Service Bulletin No: 53-012

Modification No: EC-09-0594

**FUSELAGE - GENERAL
INSPECTION FOR GALVANIC CORROSION ON THE UPPER LEFT LONGERON AND REPLACEMENT
OF THE CHAFING PLATES****1. Planning Information****A. Effectivity**

Canopy-lock Chafing Plates - Removal and Installation
Figure 1

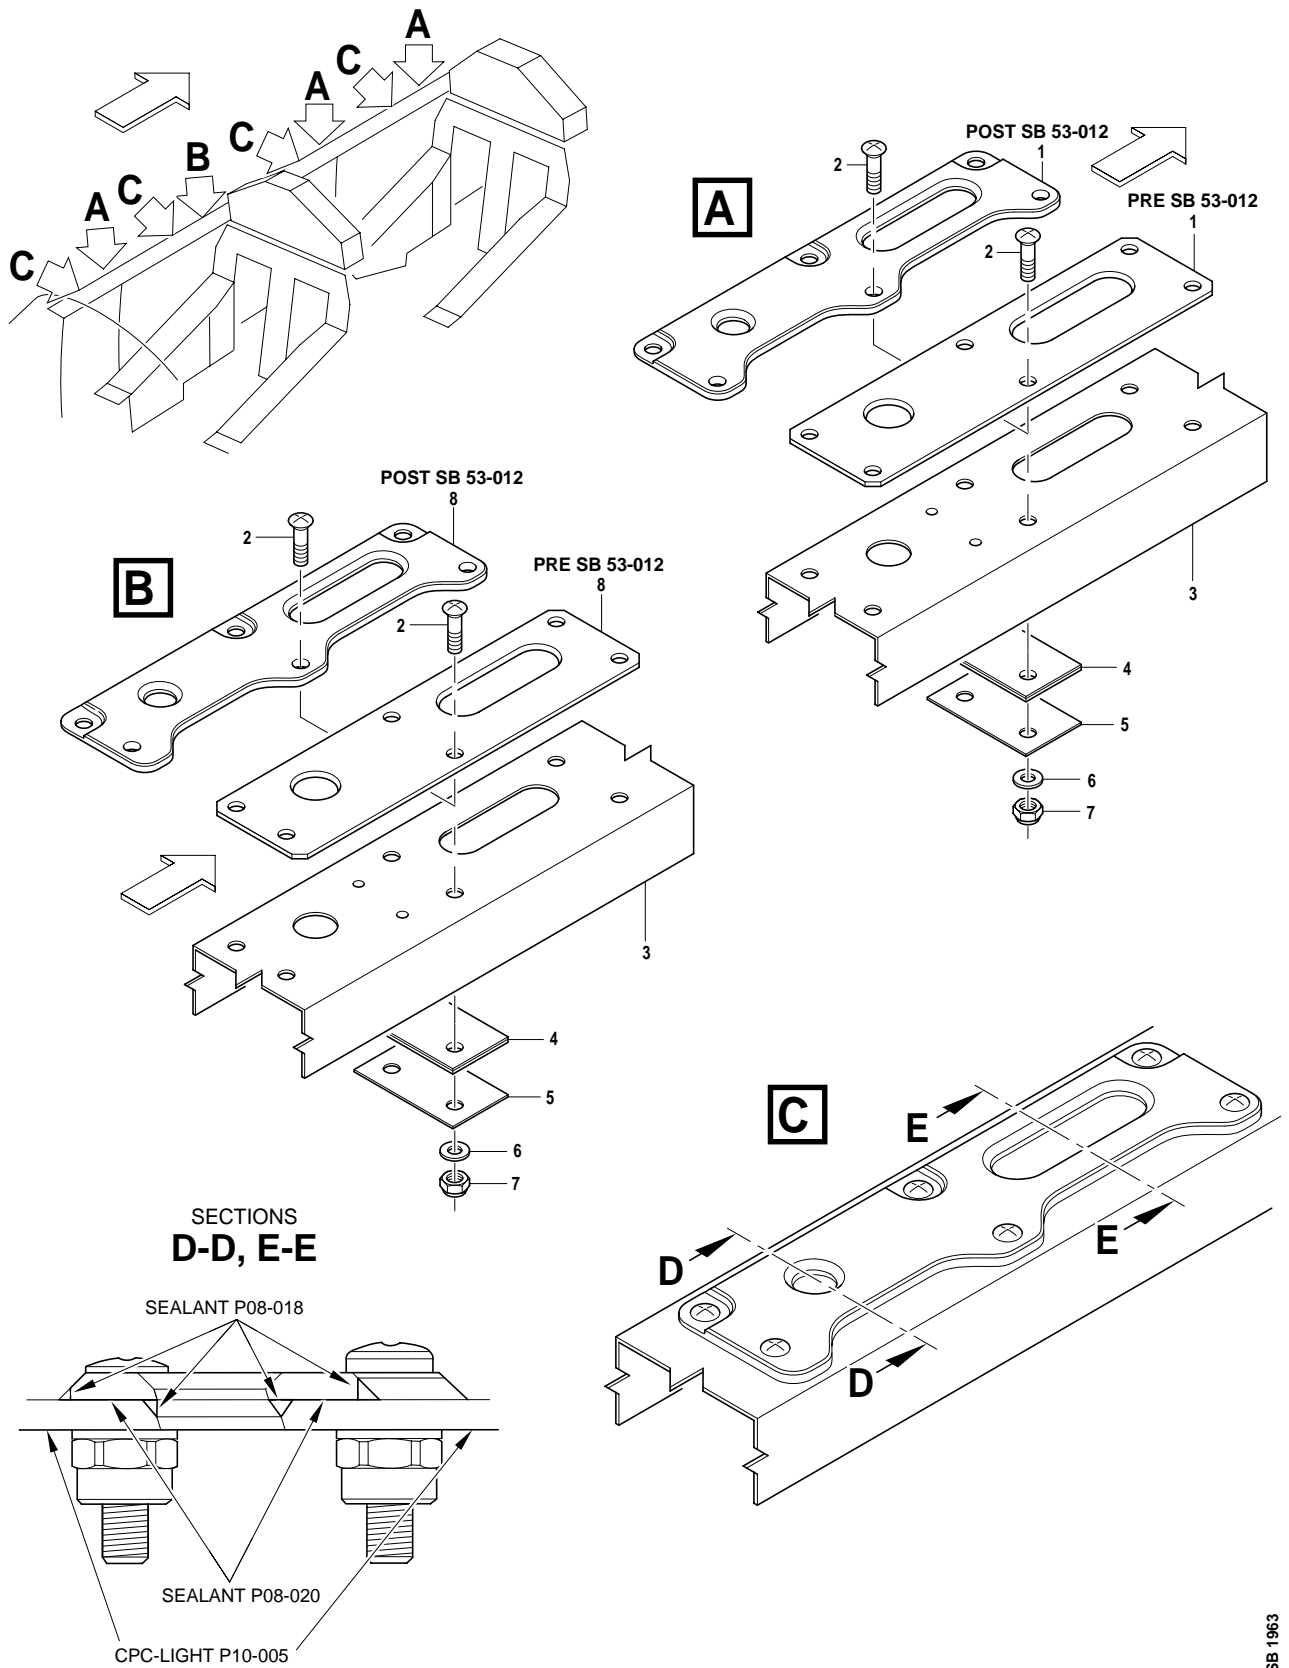
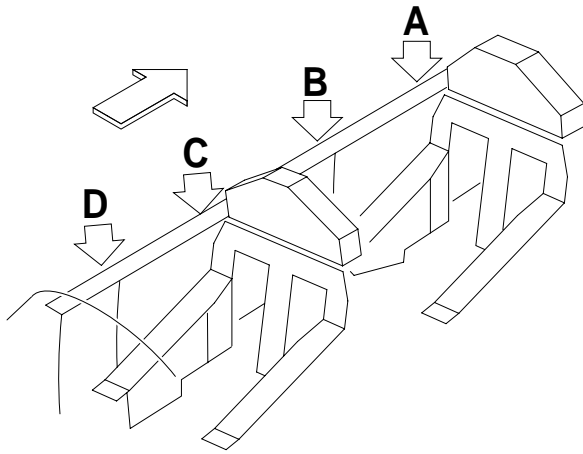
Corrosion has been reported on the upper left longeron underneath the chafing plates for the canopy door latches.

Do an inspection of the longeron in the specified areas and, if necessary, remove the corrosion. Apply to Pilatus for a repair scheme if the removal of corrosion decreases the metal thickness to less than the specified limits. Install new, more robust, chafing plates.

- (g) If the thickness of the remaining metal is less than:
- 1,8 mm (0.071 in.) at the FWD chafing plate (1) in the front cockpit
 - 2,3 mm (0.091 in.) at the AFT chafing plate (1) in the front cockpit
 - 2,1 mm (0.083 in.) at the FWD chafing plate (8) in the rear cockpit
 - 1,8 mm (0.071 in.) at the AFT chafing plate (1) in the rear cockpit,

- (h) If you do not find corrosion in Para. 3.B.(2)(c), measure and record the thickness of the metal in the bare metal areas of the longeron (3). Metal thickness which is less than 2.5 mm (0.098 in.) shows that a blend repair has been done in the area. Make an entry in the Aircraft Logbook to record the thickness if you find that a blend repair has been done.

- (k) Put the new chafing plates (1) (P/N 553.20.09.326) and (8) (P/N 553.20.09.327) in position on the longeron (3).
 - (l) Put the locking plate assemblies (5) and shim packs (4) in their recorded locations on the longeron (3) (Ref. Para 3.B.(1)).

- (m) Install the new screws (2) (P/N 935.63.11.065), the new washers (6) (P/N 938.77.11.111) and the new nuts (7) (P/N 938.07.68.303).
 - (n) Remove the unwanted sealant (Material No. P08-020).

- The chafing plates (1)
 - The chafing plate (8)
- As shown in Detail C and Section D-D and E-E.
- (q) Apply a layer of the CPC-Light (Material No. P10-005) to the lower surface of the longeron (3) in the areas of the chafing plates (1) and the chafing plate (8).

Feedback Form (Front Cockpit)
Figure 2, Sheet 1 of 2

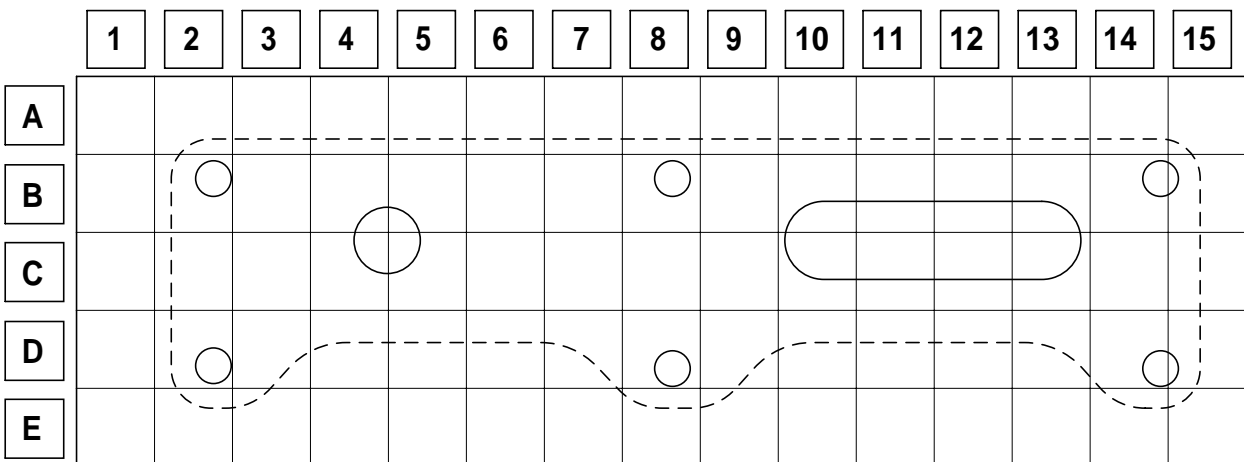
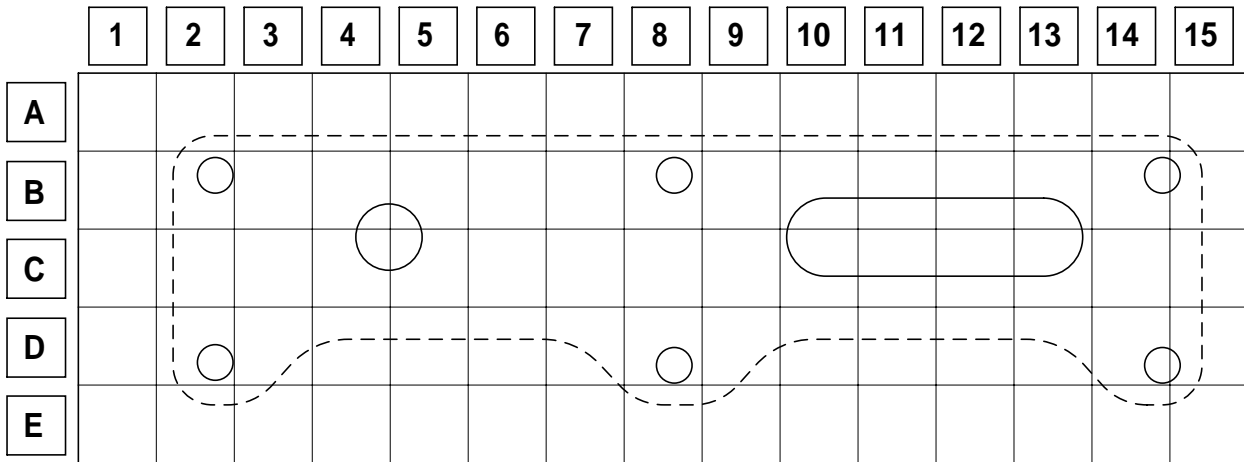
use the feedback form (Ref. Fig. 2) to record the values and apply to Pilatus for a repair scheme. The address is:

NOTE: The correct thickness of the metal is 2.7 ± 0.2 mm (0.106 ± 0.008 in.). You can use the feedback form (Ref. Fig. 2) to record the values.
